**GDR & MVR1600 ARE
SIMILAR IN DIMENSIONS.
BOTH DESIGNED TO GO
IN STANDARD DELTA
CUBICLE**

Pre-charge and control terminals are different on GDR and MVR1600.

Figure 1-14. - Cubicle Busbar Assembly for GDR721

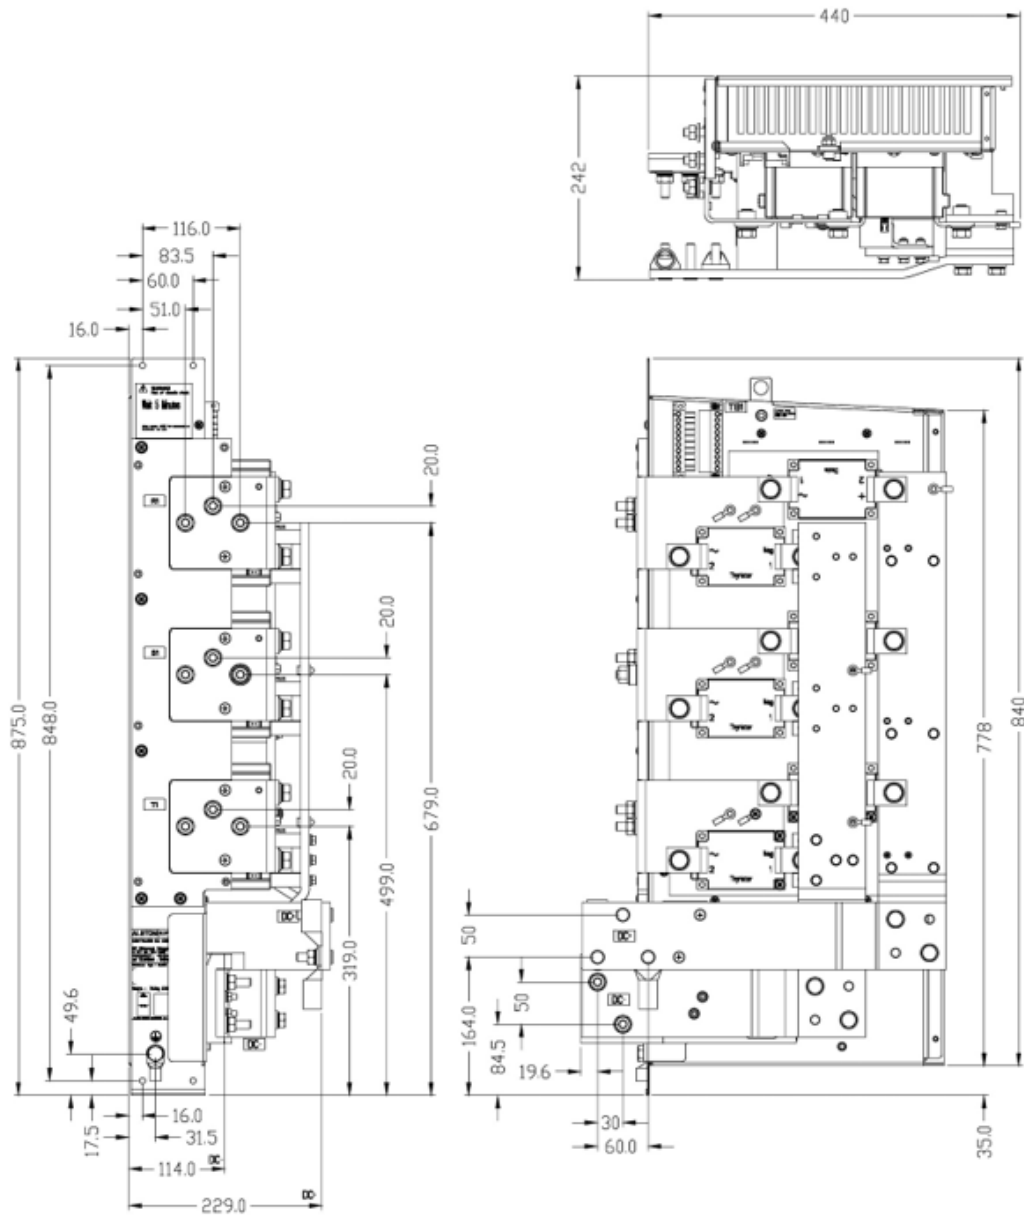
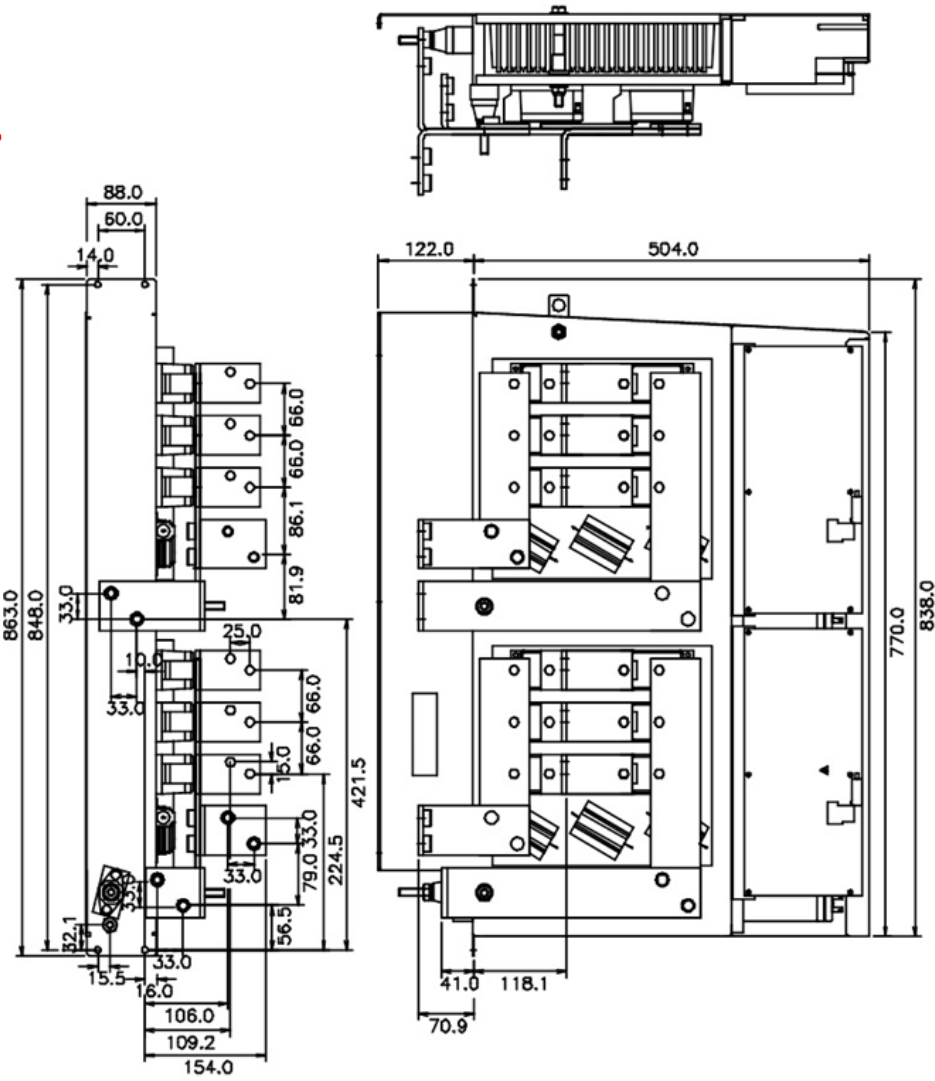
< GDR MAY ALSO HAVE
BUS ASSEMBLY
EXTENSION LIKE THIS

Figure 2-13. - Rectifier Bridge Module Terminals (GDR633-4601, GDR872-4601 & GDR1168-4601)

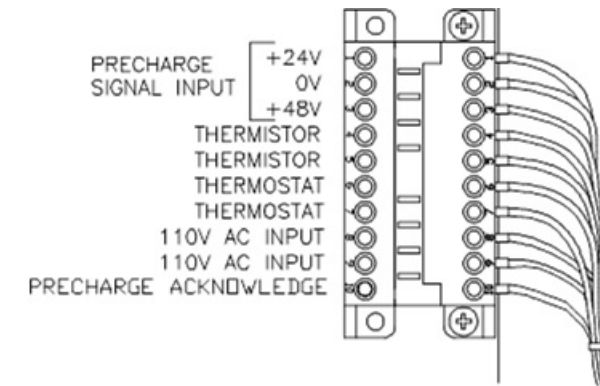
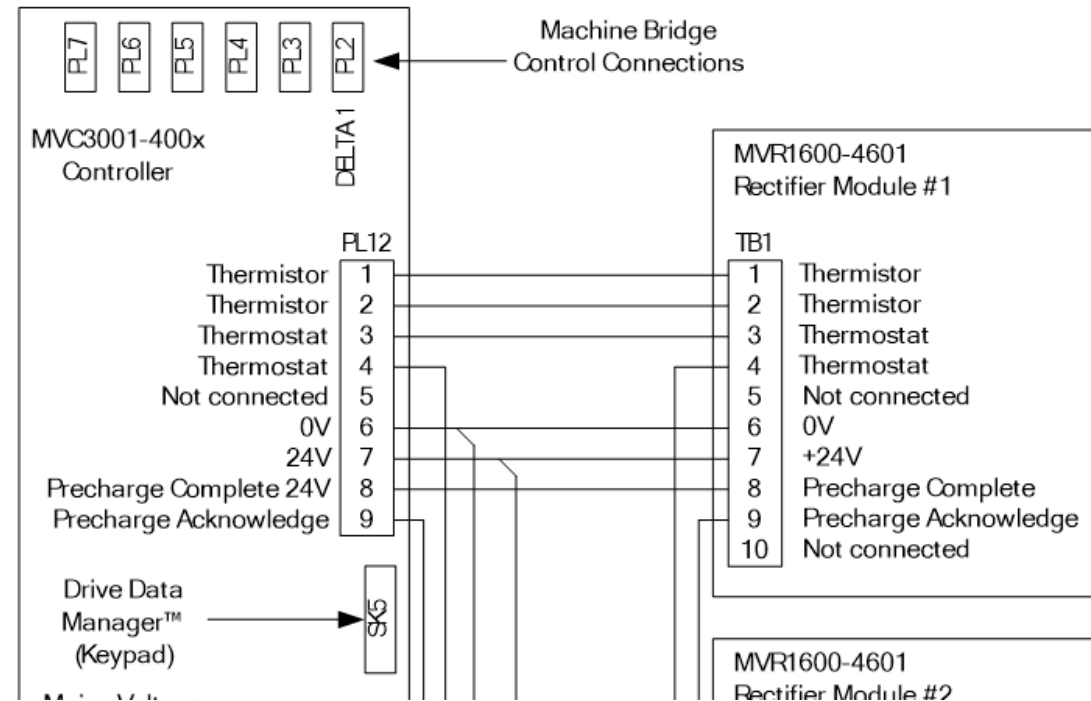
It should be possible to re-configure the control wiring to make it suit the MVR1600.

Note the 110V a.c. used on the GDR is not needed on the MVR.

- The MVR1600 is NOT plug and play compatible with GDR rectifier. However, it could be made to work.
- Some engineering resource would be needed to plan the conversion. This would be done after you had visited site to study the installation.
- This conversion would likely involve making up extension power cables to route both the DC and AC terminals from the removed GDR to reach the different locations on the MVR.
- The control wiring would need to be slightly modified
- Ensure Delta fans are providing cooling air flow for rectifier and safety shrouds in place as per manuals and data sheets.
